for
Manual No. 68P81067C40-A
MT1000® Instruction Manual

This revision outlines changes that have occurred since the printing of the manual or previous revisions. Use this information to supplement your manual. Installation of these changes in earlier equipment is not necessary except as recommended in Motorola Service and Repair Notes (SRN's).

- 1 LOWBAND TRANSCEIVER CIRCUIT BOARD AND SCHEMATIC DIAGRAM
- 2 LOWBAND Electrical Parts List, Transceiver Board TPLF-3876-A

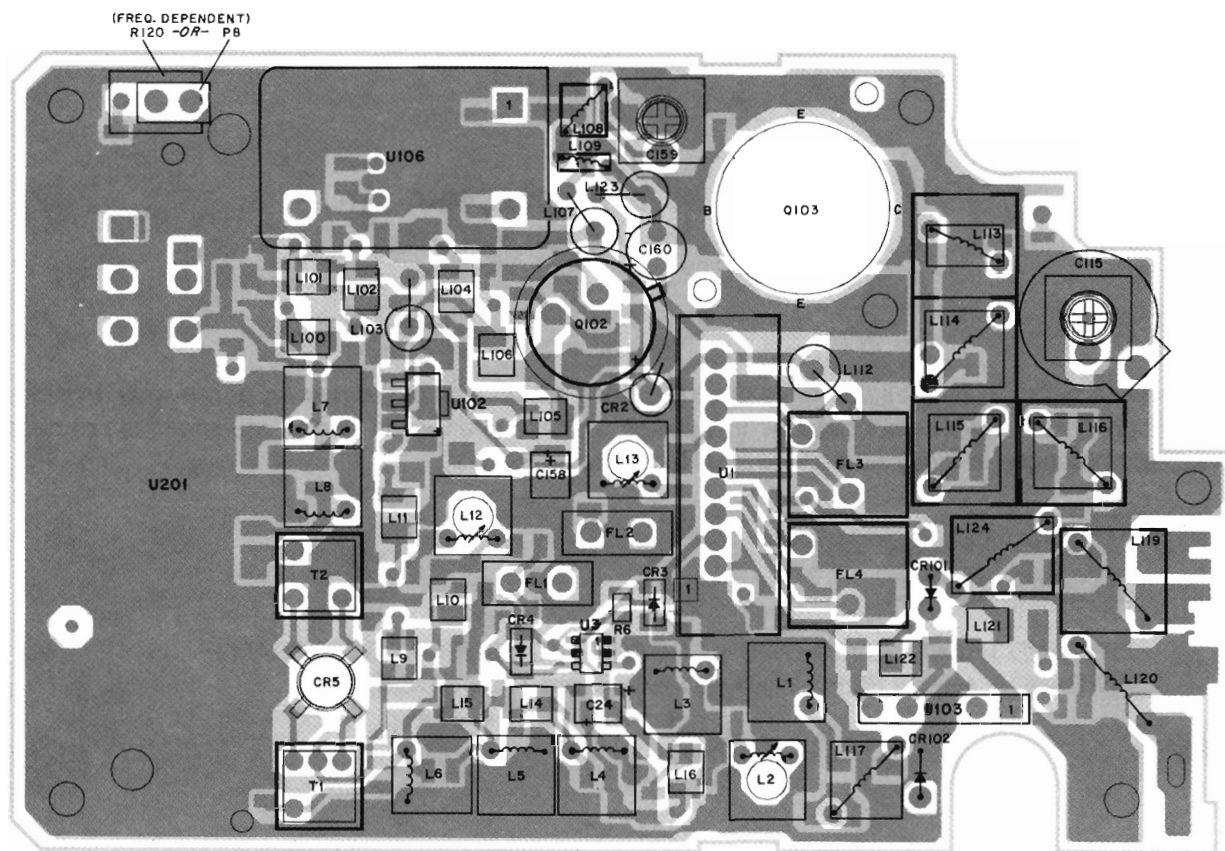
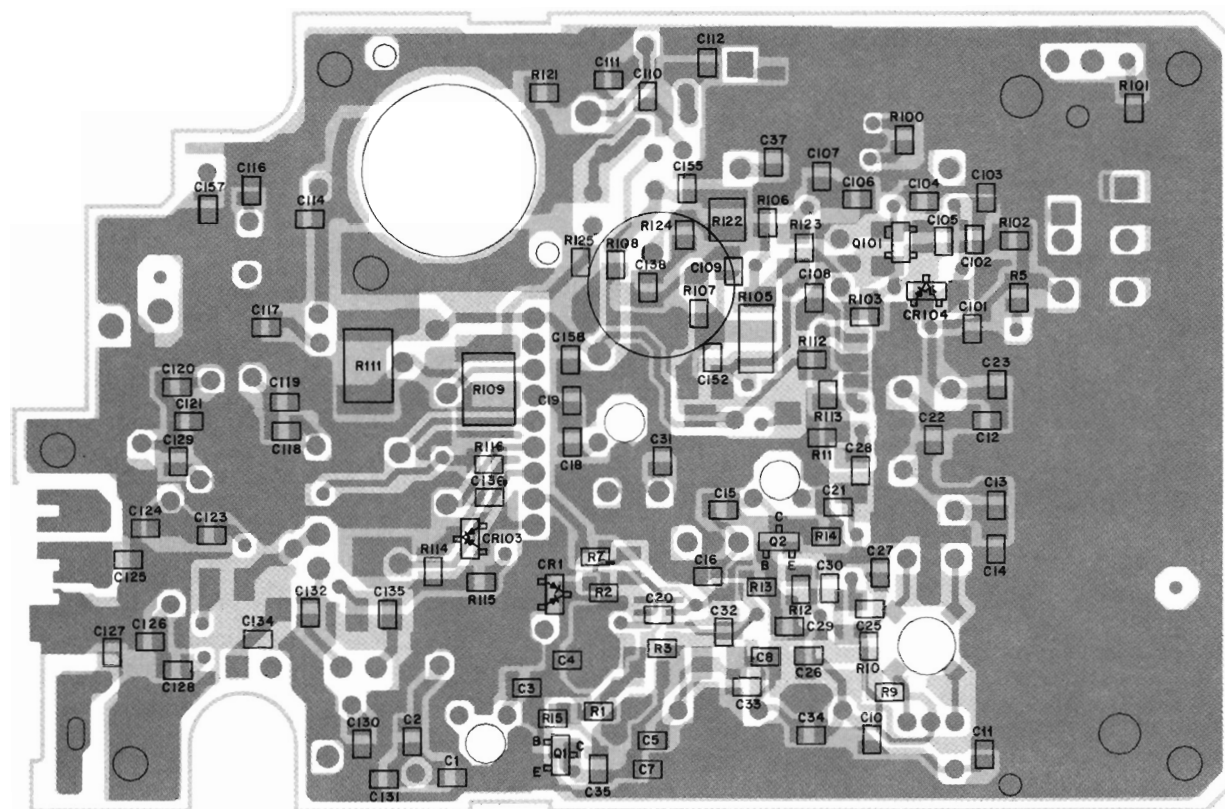
- 1 On page 71, **LOWBAND TRANSCEIVER CIRCUIT BOARD AND SCHEMATIC DIAGRAM**, replace circuit boards and schematic with the new drawings provided.
- 2 On page 72, **LOWBAND Electrical Parts List, Transceiver Board**, change the following:
